ADDENDUM NO. 2

WASTEWATER TREATMENT PLANT EXPANSION  
KYLE, TEXAS

CONTRACT DOCUMENTS, DRAWINGS AND TECHNICAL SPECIFICATIONS

P:\PR55768\Cadd\Sheets\23 YARD PIPING ENLARGED PLAN 2 PH2.dwg 10/31/2019 9:42:39 AM Doss, Colleen

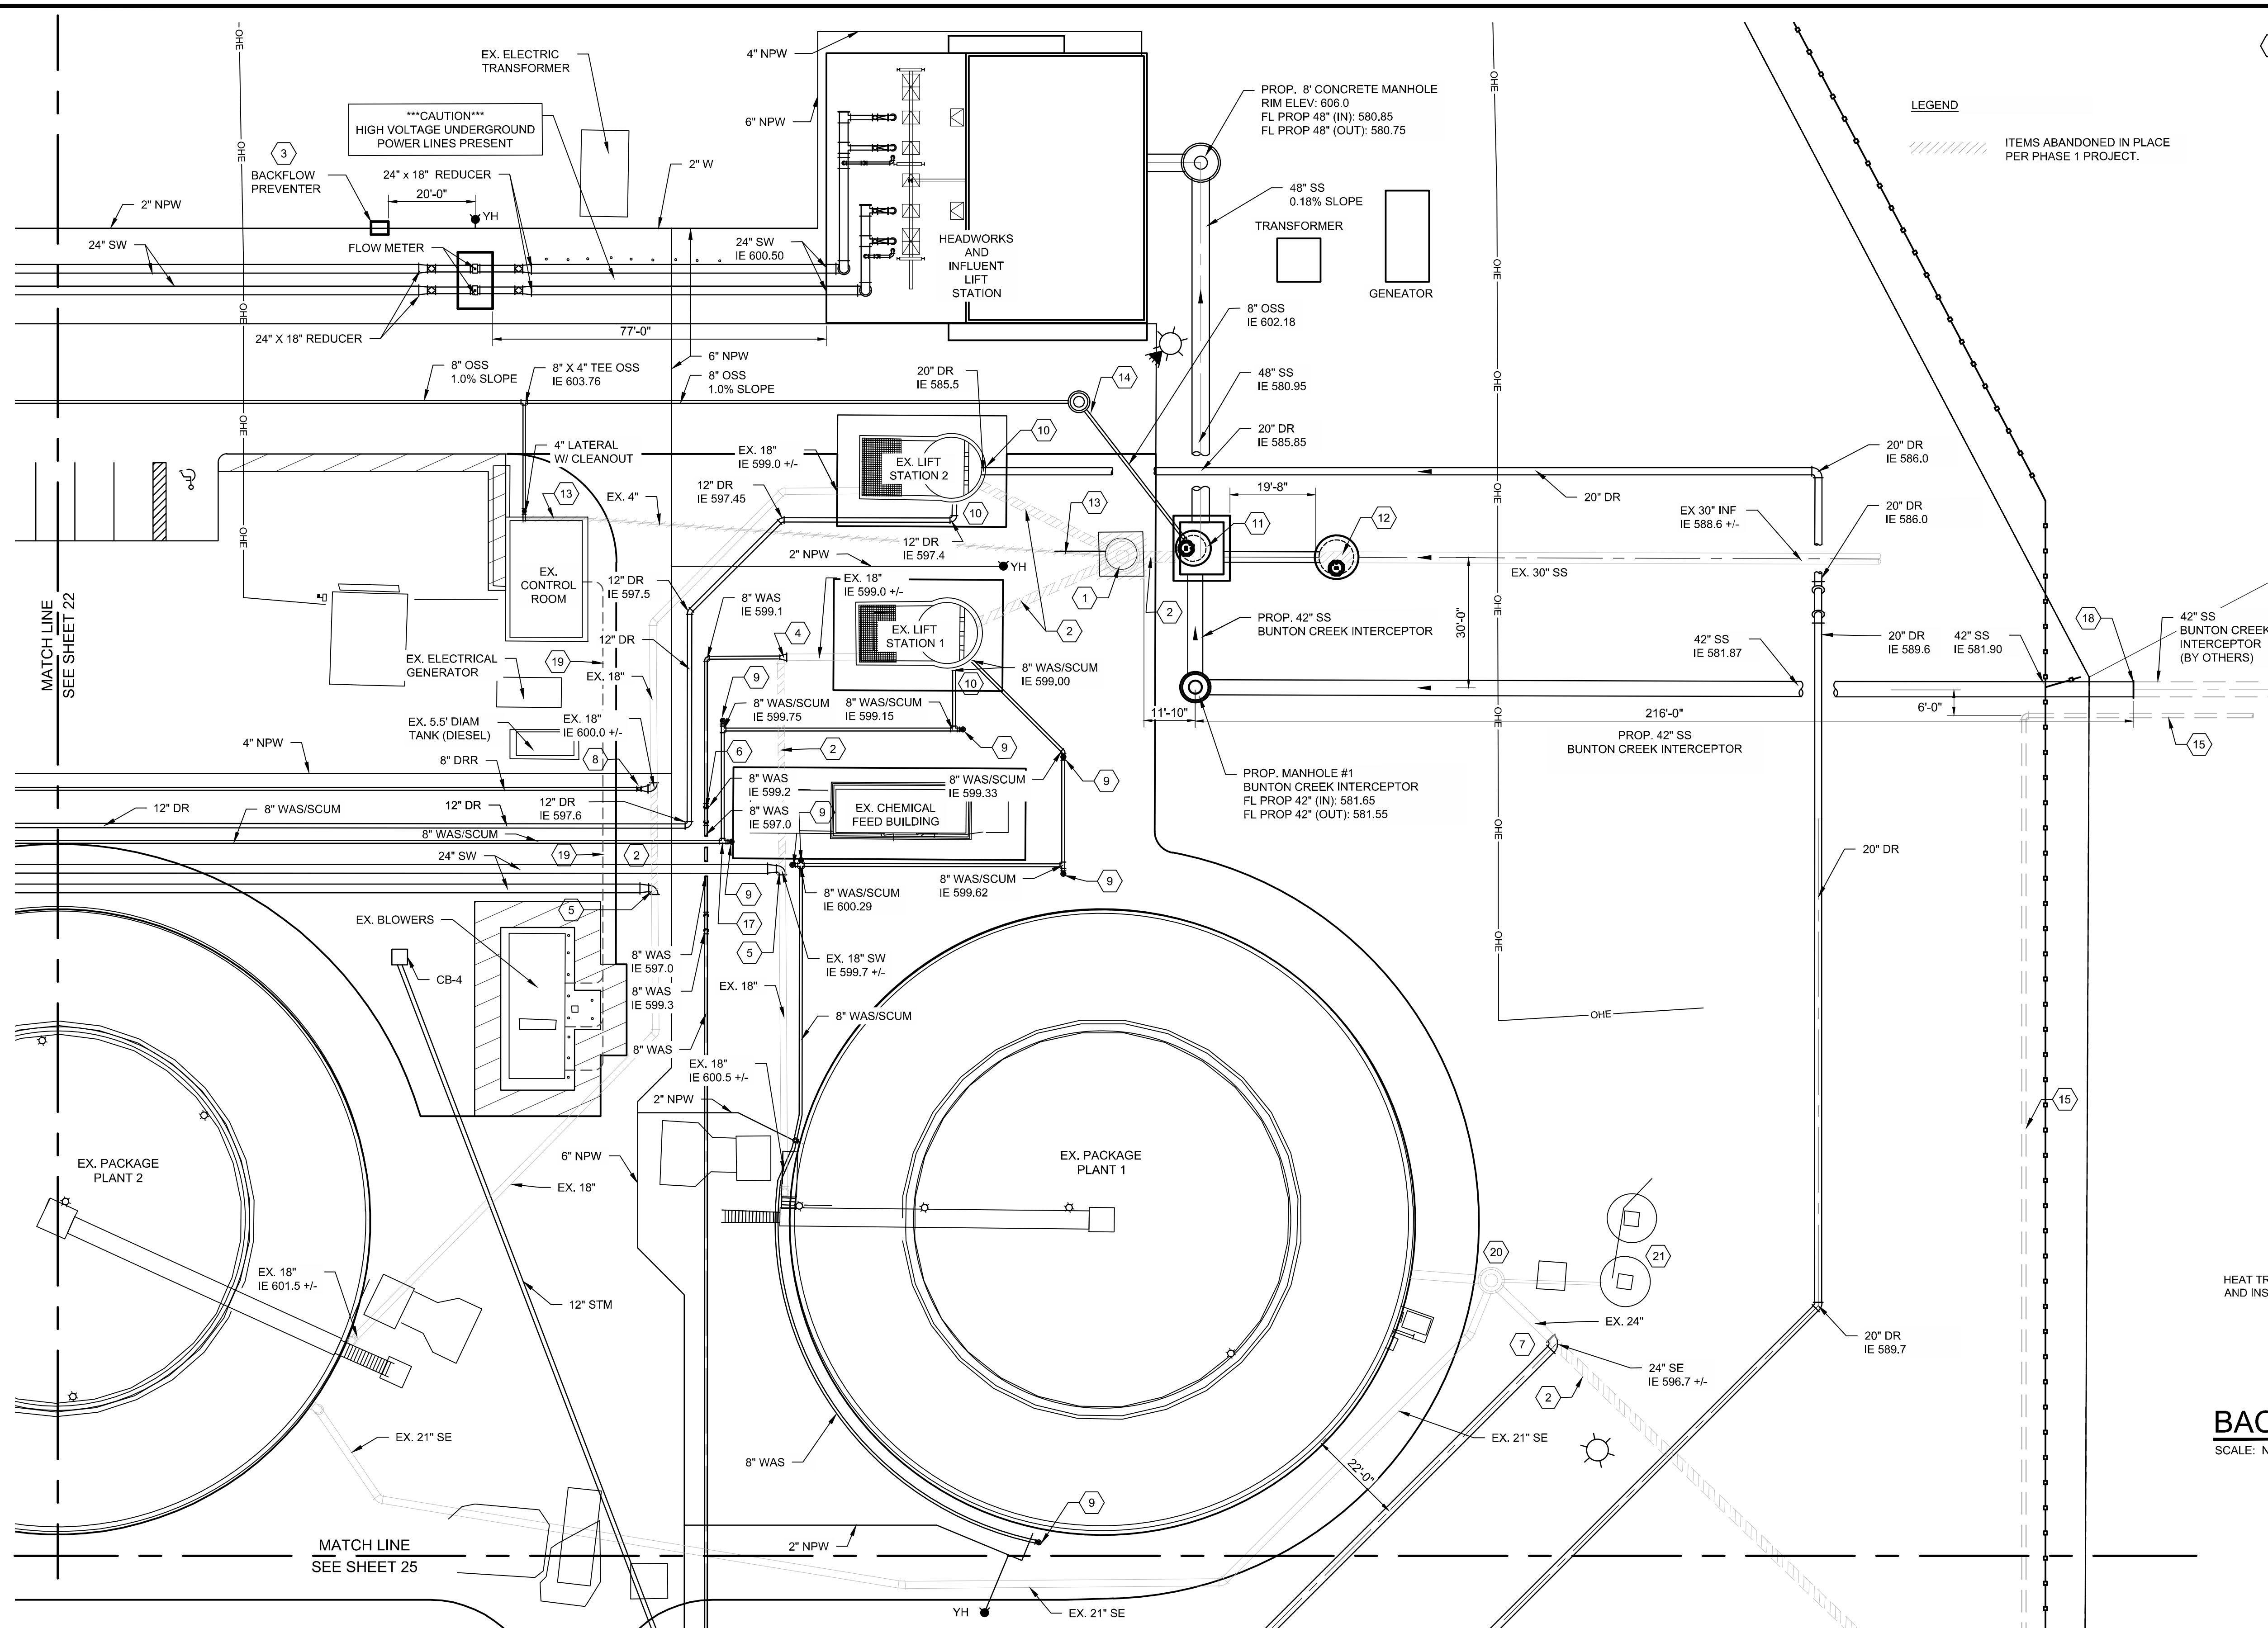
- 91      **Question:**      Drawing 23 is showing the new 42" SS Bunton Creek Interceptor line to be installed by others. This line is connecting to the stub out in the Influent Junction Box. We need to know what pipe is being installed. We are assuming that this pipe is not restrained joint type. Are we to just stub out a push on joint bell end piece of pipe with a push on joint plug? Is it up to the other contractor to adapt to the pipe end that this project provides? Please clarify.

- Answer:**            *Interconnection with 42" SS Bunton Creek interceptor will occur at Station 2+10.77, as indicated on revised Sheet 23 issued with this addendum and the two answers for Questions 10 and 13 above. Timing of the interceptor installation by others is not currently determined, so interconnection between new and existing 42" closed-profile PVC per Section 33 05 42, or providing temporary cap on ready-to-interconnect pipe end, are the two scope options for the WWTP project's 42" SS segment.*

P:\PR55768\Cadd\Sheets\24 YARD PIPING ENLARGED PLAN 3 FH2.dwg 10/9/2019 9:46:14 AM Doss, Colleen

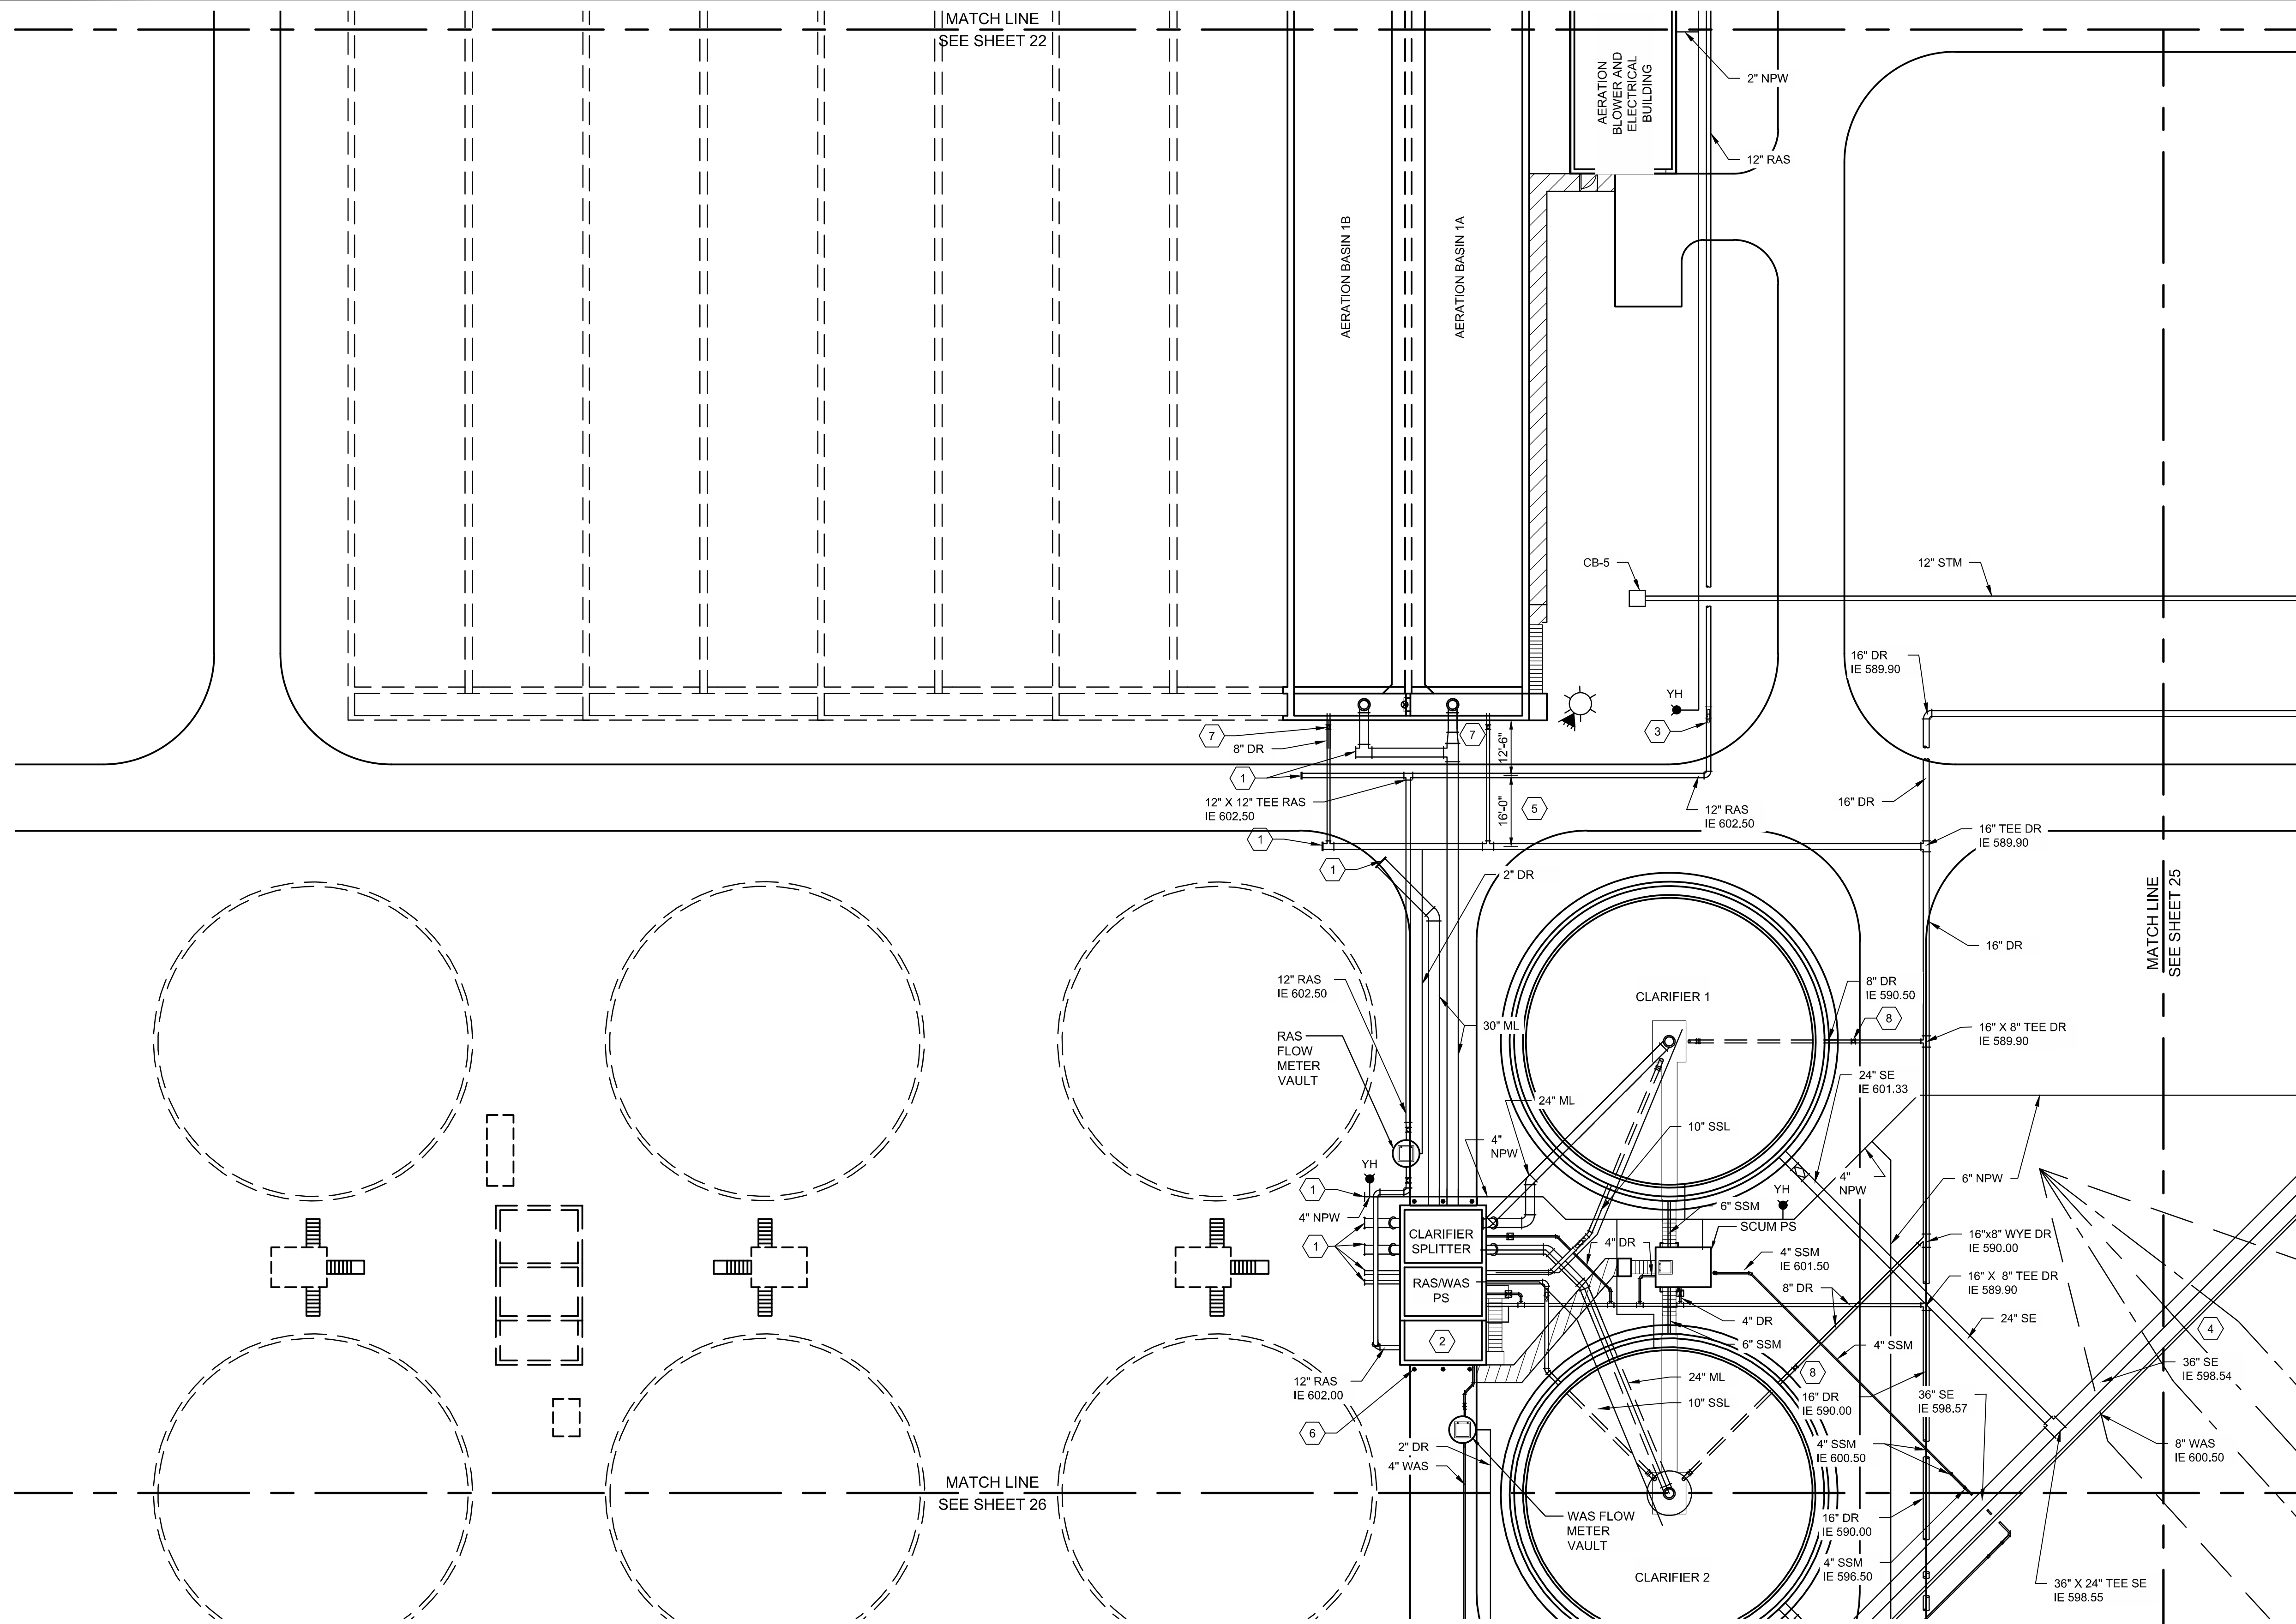
- Answer:** Provide ten wall-mounted fire extinguishers for the Operations Building (eight Class A, one Class B, and one Class C).
- 124 **Question:** Looking at drawing - 24, showing the two 8" drain lines coming out of the Aeration Basins to the 16" drain line, we do not see any valves in these lines. Drawings 51 and 52 also do not show valves in the drain lines. Please review and clarify.

- Answer:** Provide two 8" buried drain plug valves, per revised Sheet 24, issued as part of this addendum.
- 125 **Question:** Looking at drawing - 24, we see the two 8" drain lines coming out of the Clarifiers to the 16" drain line. We do not see any valves in these lines. Please review and clarify.

- Answer:** Provide two 8" buried drain plug valves, per revised Sheet 24, issued as part of this addendum.
- 127 **Question:** Section 46 43 21. 1.02 – Manufacture’s representative shall provide a maximum of one (1) trip with a total of 3 days on site. Please confirm that its one trip for the two clarifiers combined. If the clarifiers are expected to start up at different times, two (2) trips would be required.
